FPR Example Comments

Historic Resource-related Comment

CONSTRUCTION PLAN	
SR 316 FM CEDARS RD TO SUGARLOAF PKWY	
DECEDED:	DATE:
BACHECKED:	DATE:
CONNECTED:	DATE:
VERIFIED:	DATE:
DRAWING No. 13-0004

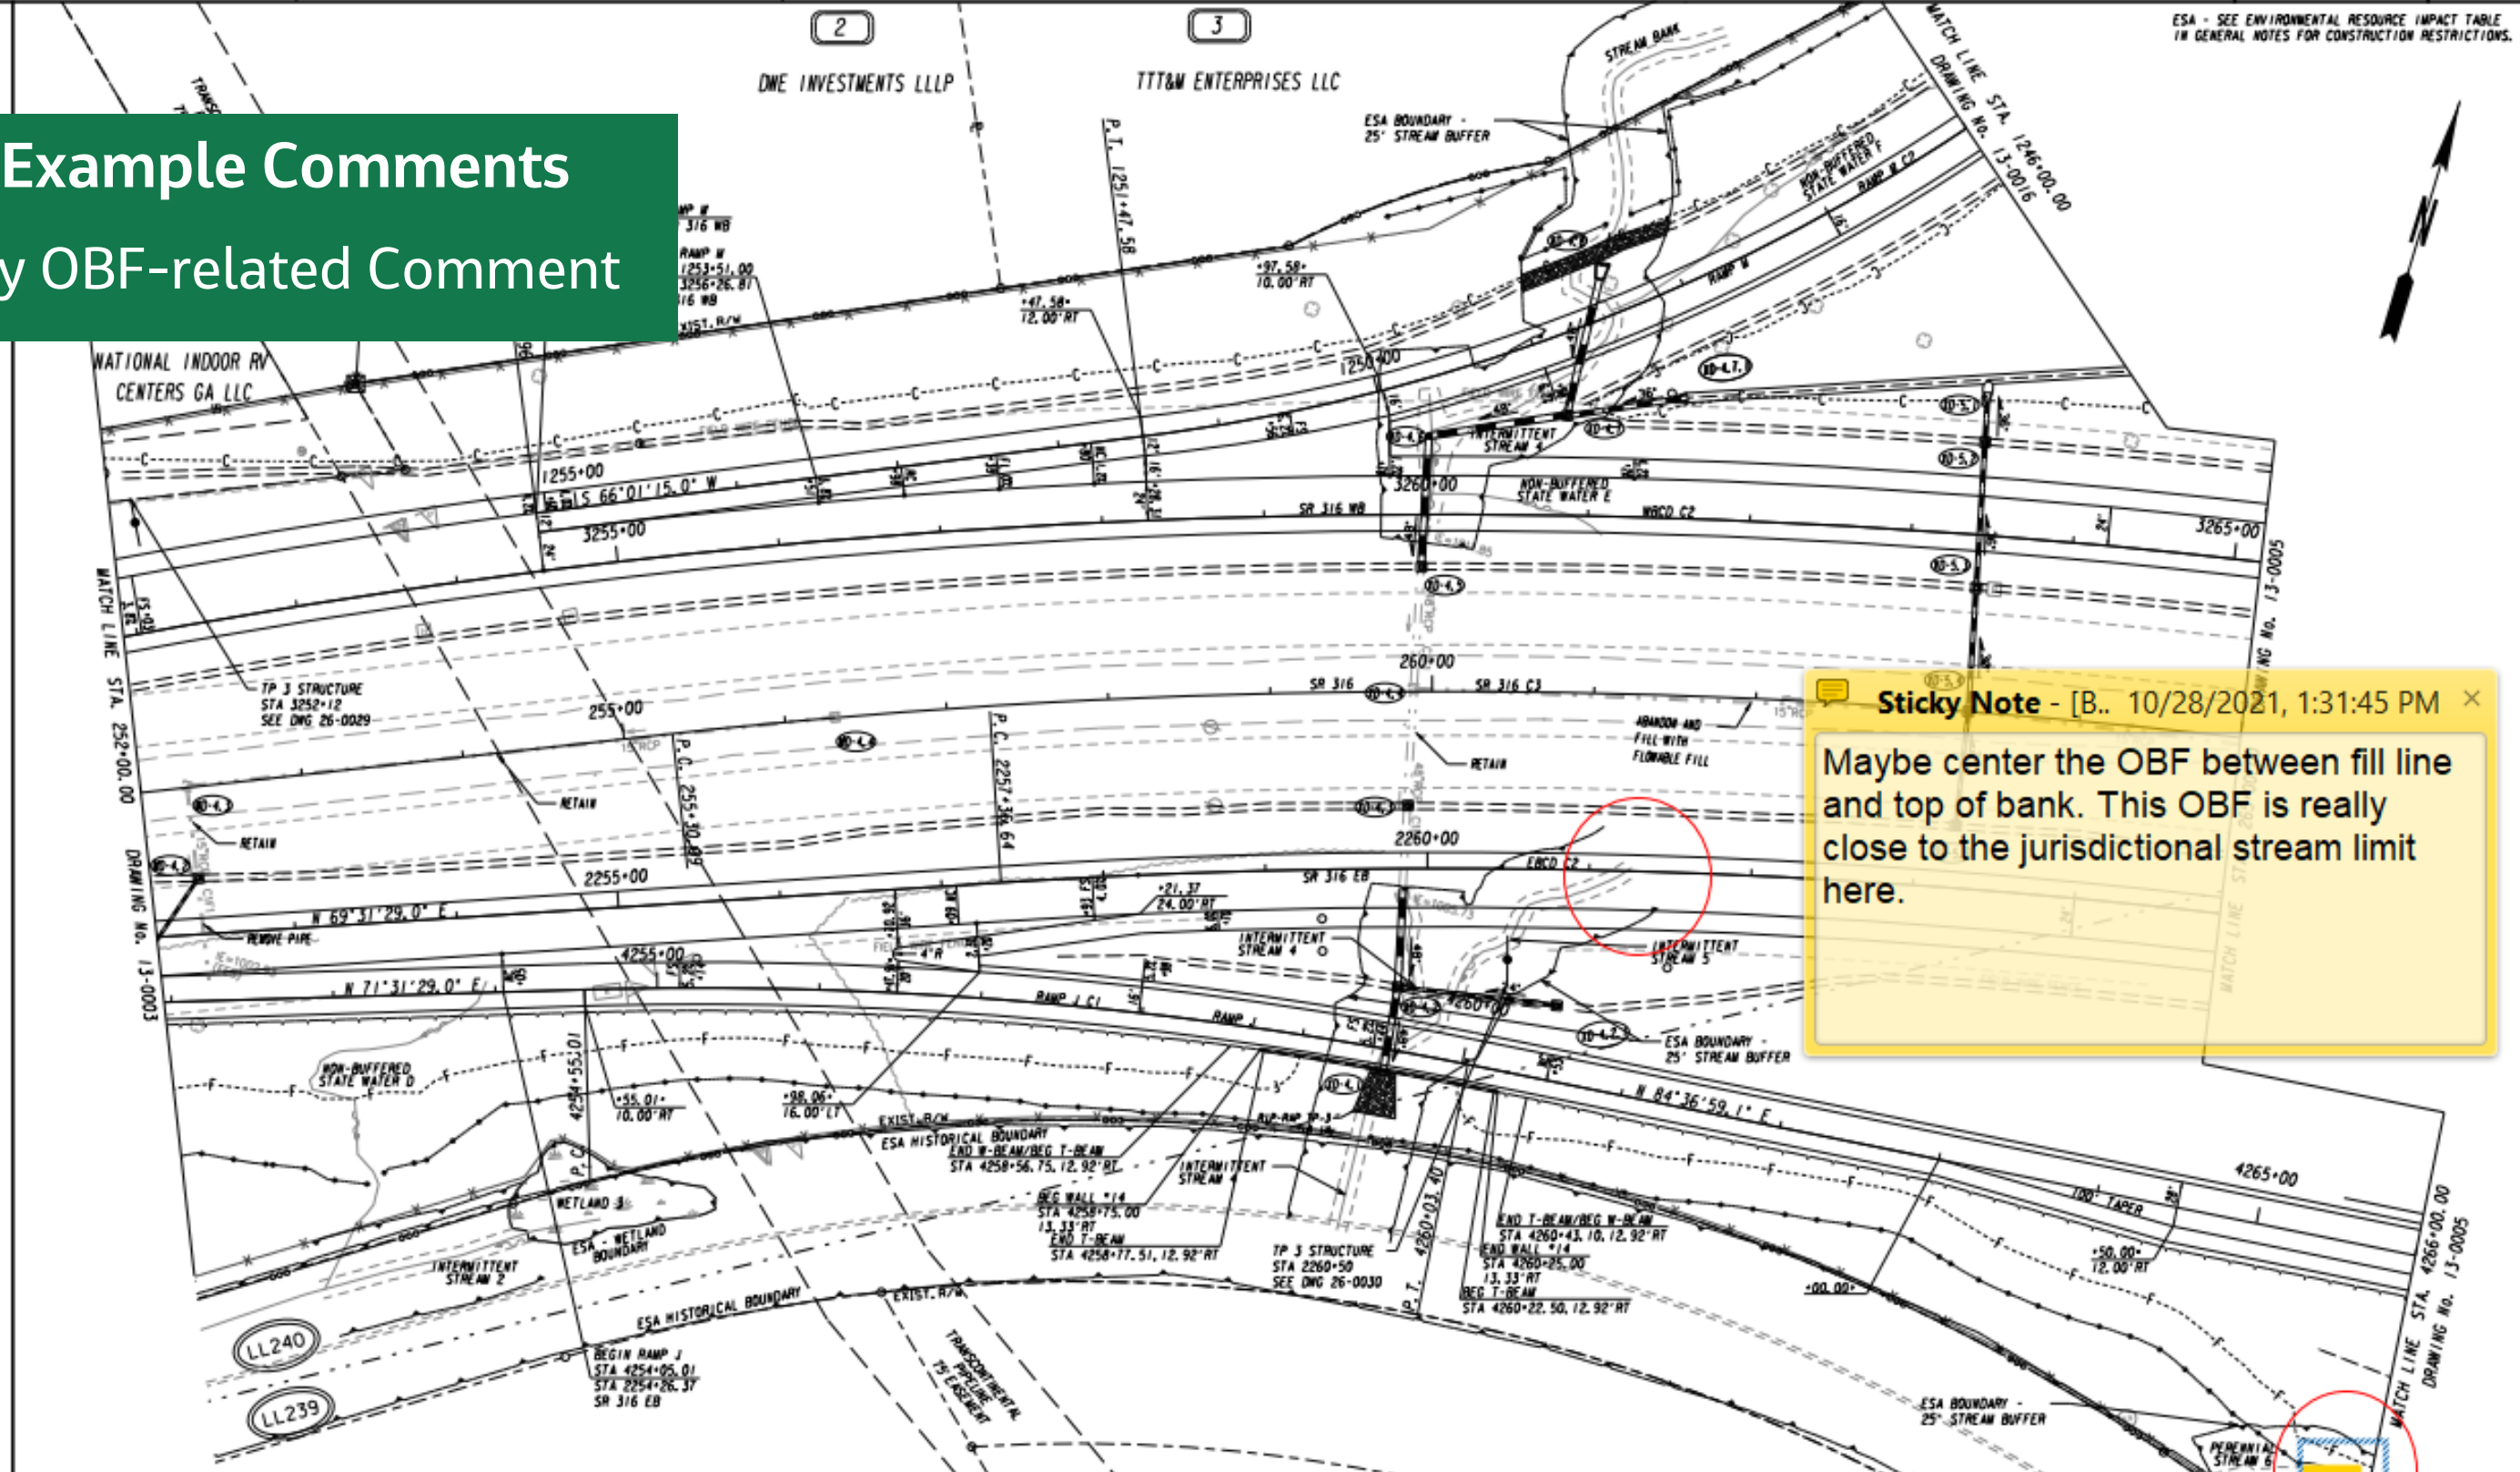
Maybe center the OBF between fill line and top of bank. This OBF is really close to the jurisdictional stream limit here.

REVISION DATES		CONSTRUCTION PLAN	
		SR 316 FM CEDARS RD TO SUGARLOAF PKWY	
CHECKED:	DATE:	DRAWING No.	13-0006
BACHECKED:	DATE:		
CORRECTED:	DATE:		
VERIFY:	DATE:

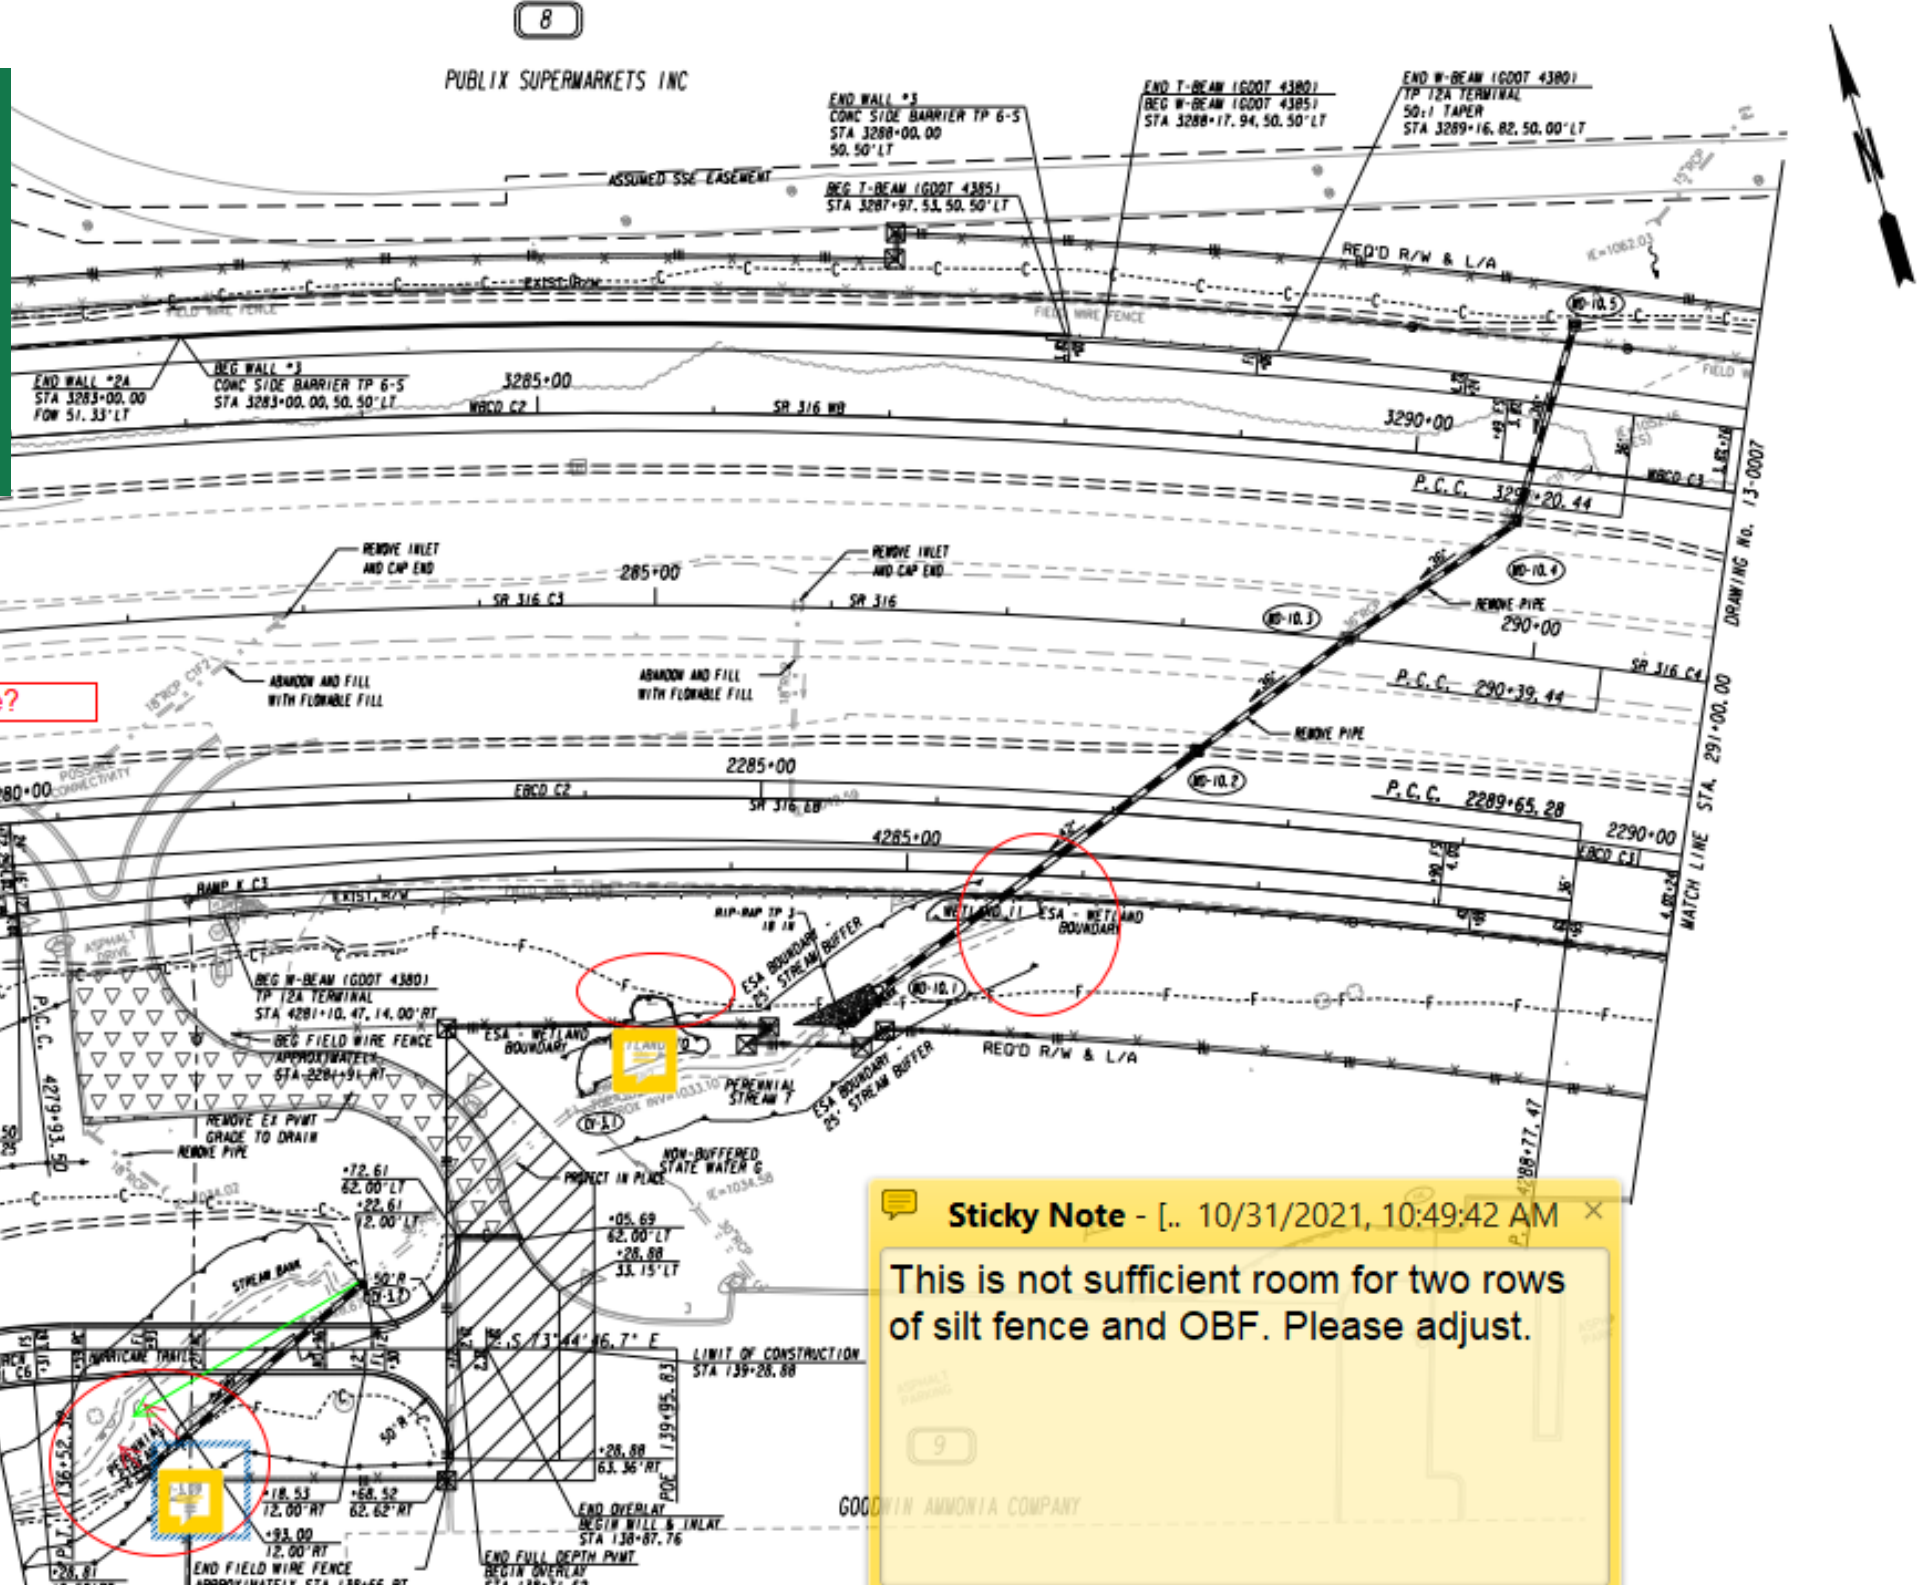
Could this pipe be aligned to discharge more directly into the stream (as green arrow is indicating)? This would potentially reduce linear feet of impact to PS 7 as well.

This is not sufficient room for two rows of silt fence and OBF. Please adjust.

CONSTRUCTION PLAN			
SR 316 FM CEDARS RD TO SUGARLOAF PKWY (SEE 13-0018A FOR ADDITIONAL DETAIL)			
CHECKED:	DATE:	DRAWING NO.	
BACKCHECKED:	DATE:	13-0018	
CONNECTED:	DATE:		
VERIFIED:	DATE:

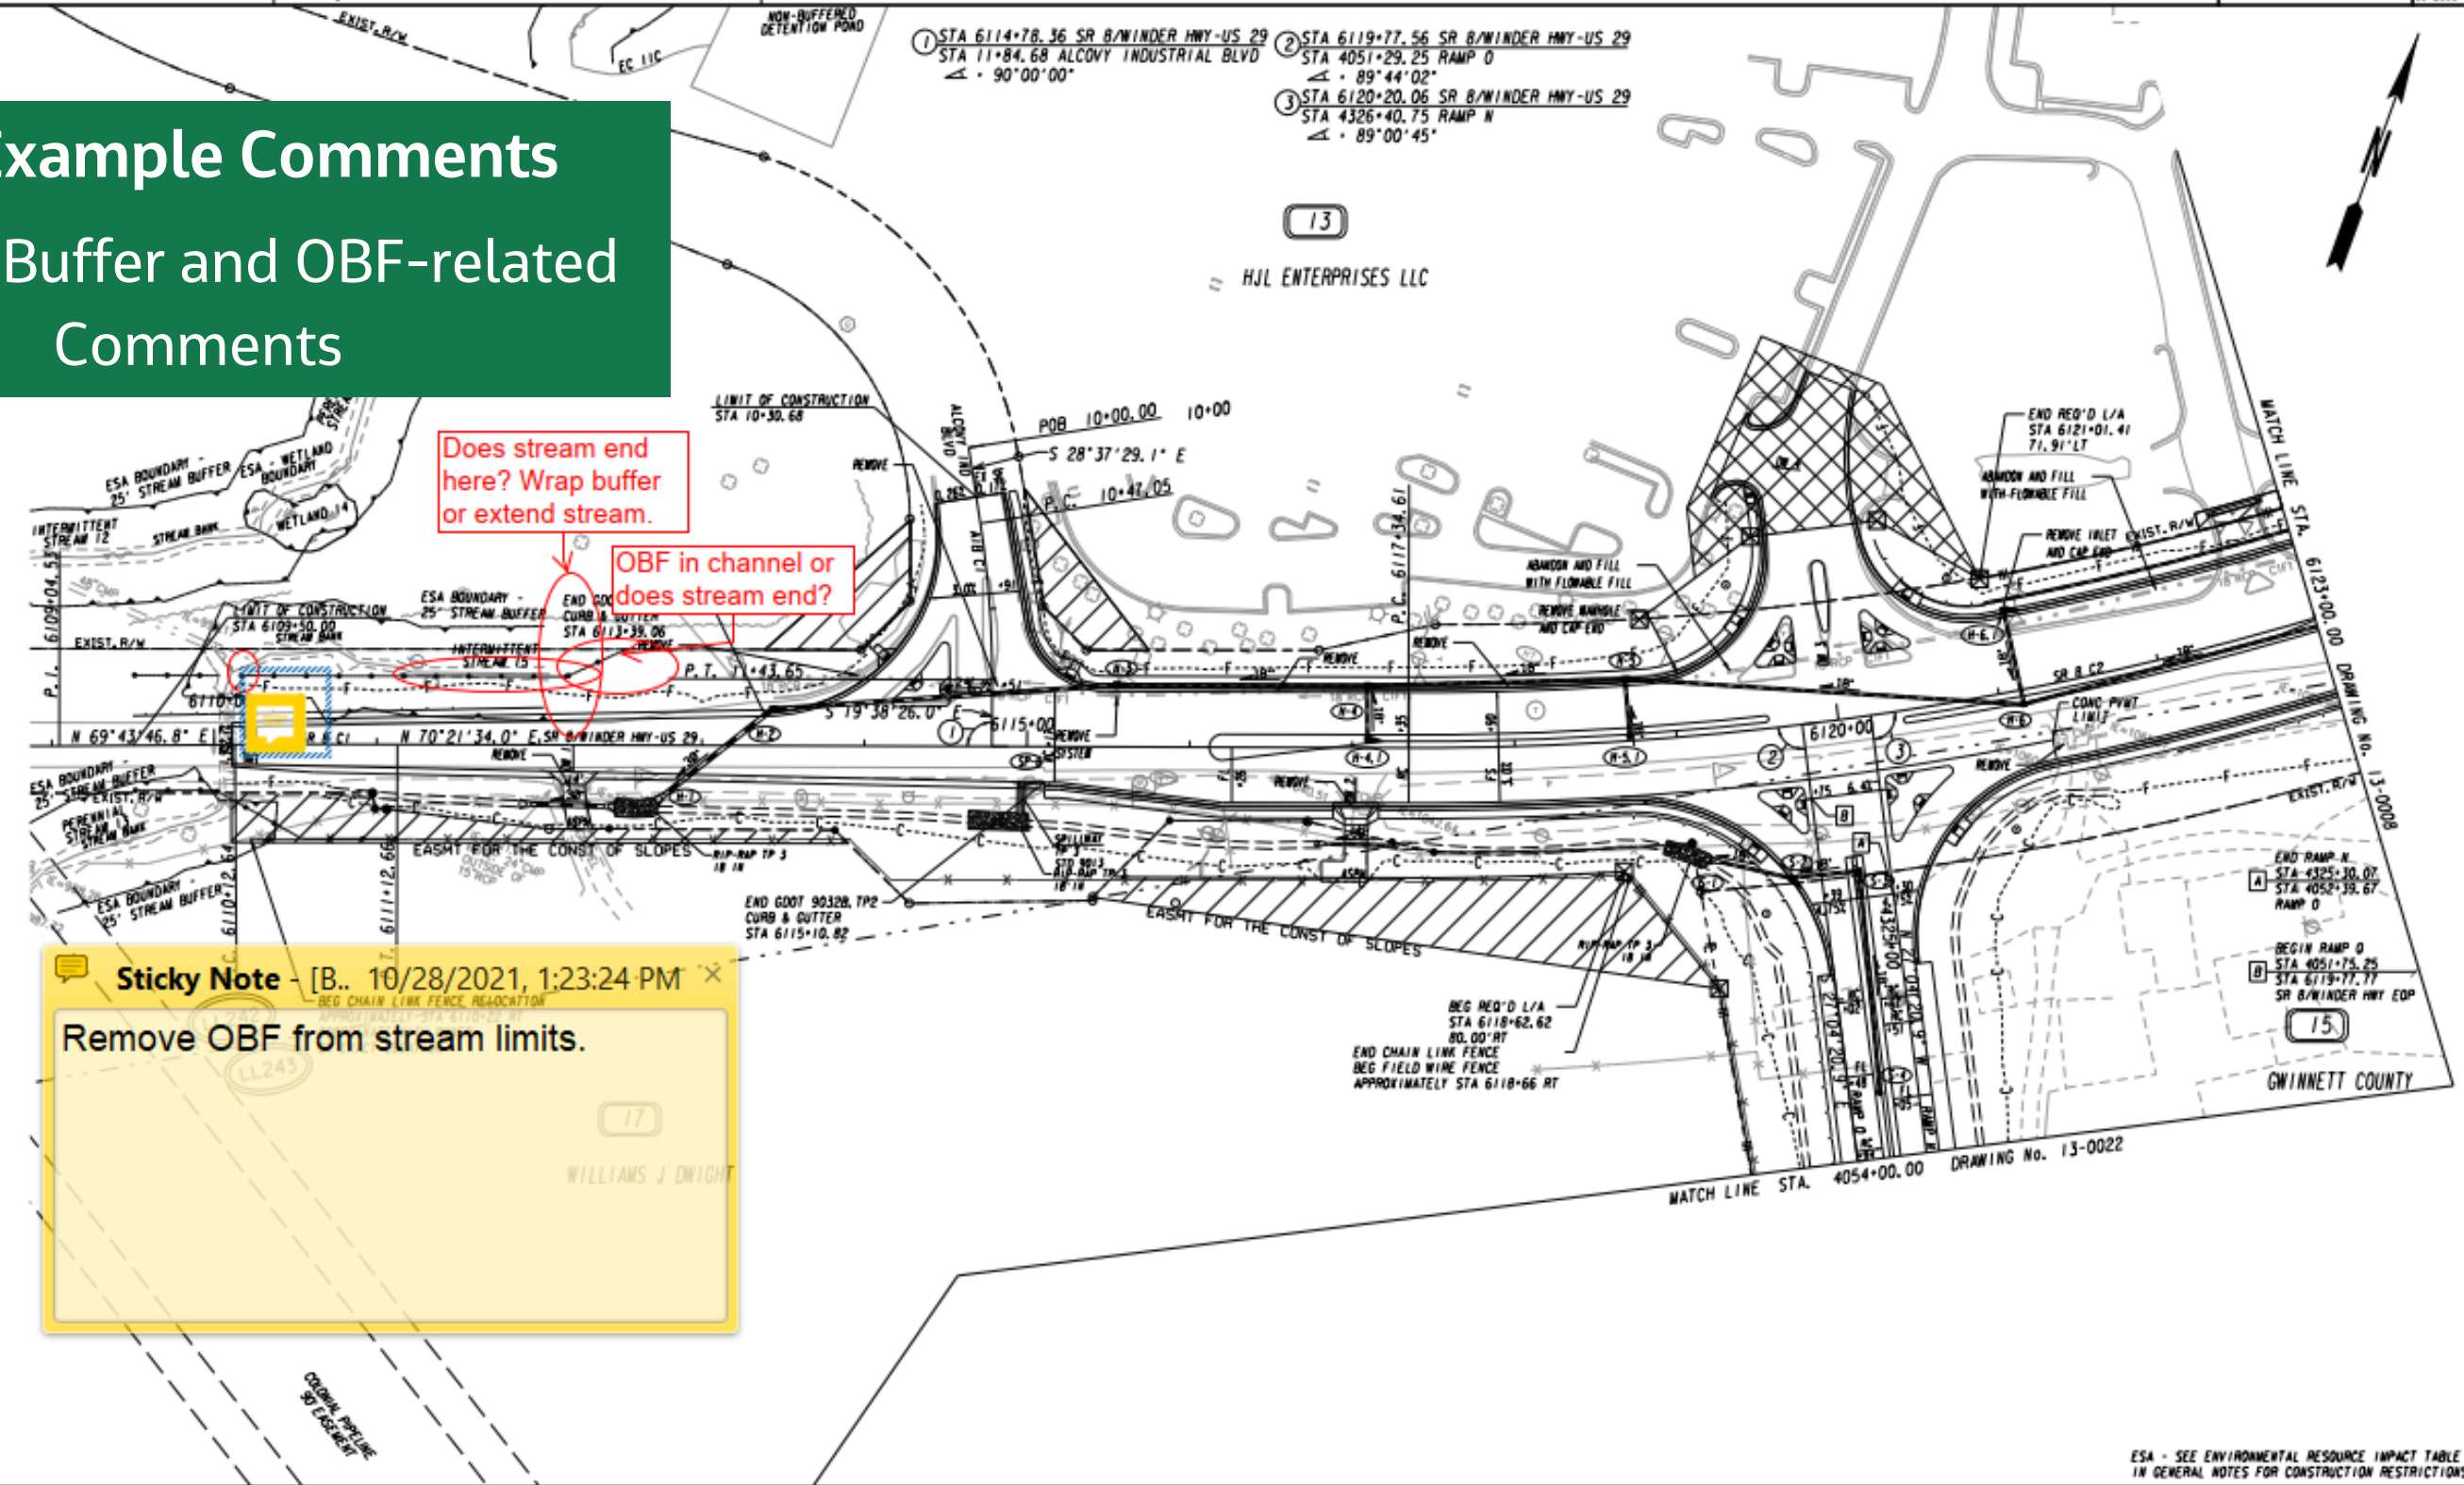
Does stream end here? Wrap buffer or extend stream.

OBF in channel or does stream end?

Sticky Note - [B.. 10/28/2021, 1:23:24 PM] X
 Remove OBF from stream limits.
